JRPP No	2011SYW010
DA Number	15/2011/DA-RA
Local Government Area	Campbelltown City Council
Proposed Development	Construction of a 6 to 8 storey mixed use commercial, retail and residential apartment development with 2 levels of basement car parking spaces
Capital Investment Value	\$28,261,000
JRPP Referral Criteria	Development exceeds \$10 million capital investment value
Street Address	Lot 3004 Stowe Avenue, Campbelltown
Applicant	Blue CHP Limited
Number of Submissions	48 - Including 19 individual objections, 27 form letters objecting to the proposal, two objections from Campbelltown City Council and 1 submission in support of the development
Recommendation	Refusal
Report by	Rad Blagojevic – Senior Development Planner

Council has received a development application for the construction of a mixed use commercial and residential apartment building development at Lot 3004 DP 1152287, Stowe Avenue, Campbelltown.

Figure 3: Height Controls within Macarthur Regional Centre Master Plan

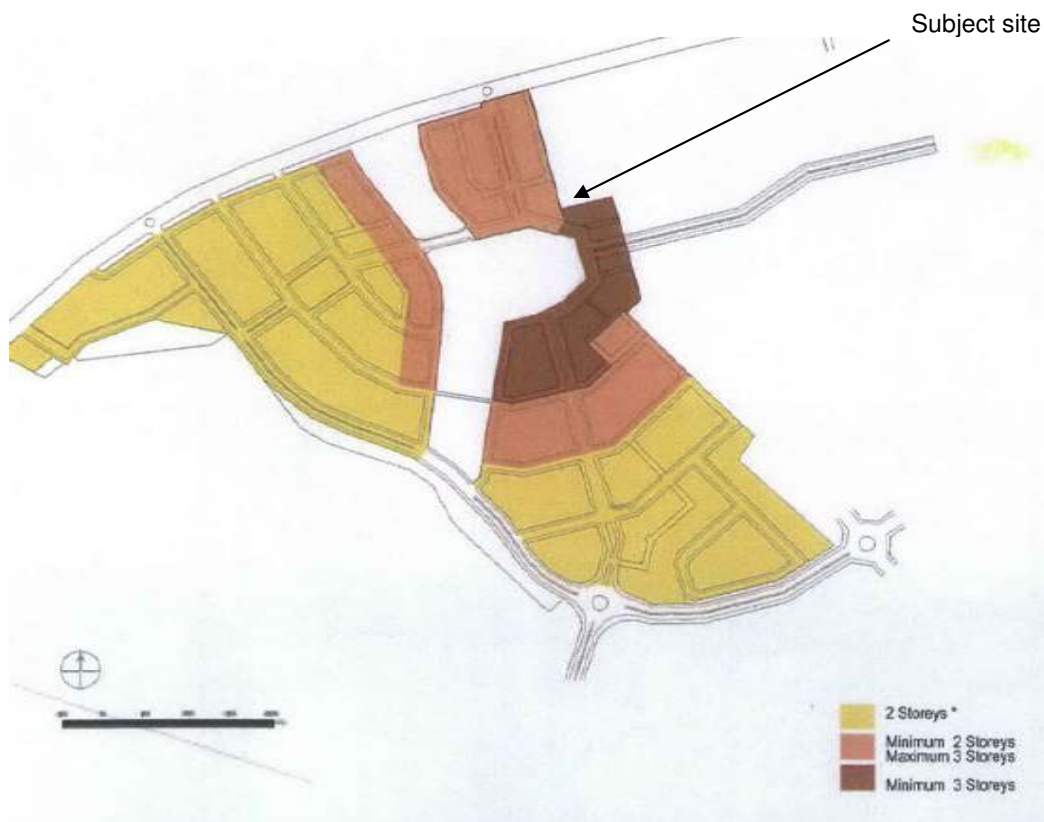
The Master Plan provides design controls that include height controls. The subject site is identified in the master plan as having being suitable for two building heights that are:

- Northern part of the site up to 3 storeys; and
- Southern part of the site a minimum 3 storeys and a maximum of 8 storeys (or 27 metres).

The proposal partially complies with the Master Plan in this regard.

Concerns have been raised about the development's non-compliance with height recommendations contained within the master plan. The proposed development has a 7 storey building on land that envisaged a maximum height of 3 stories (northern portion of site).
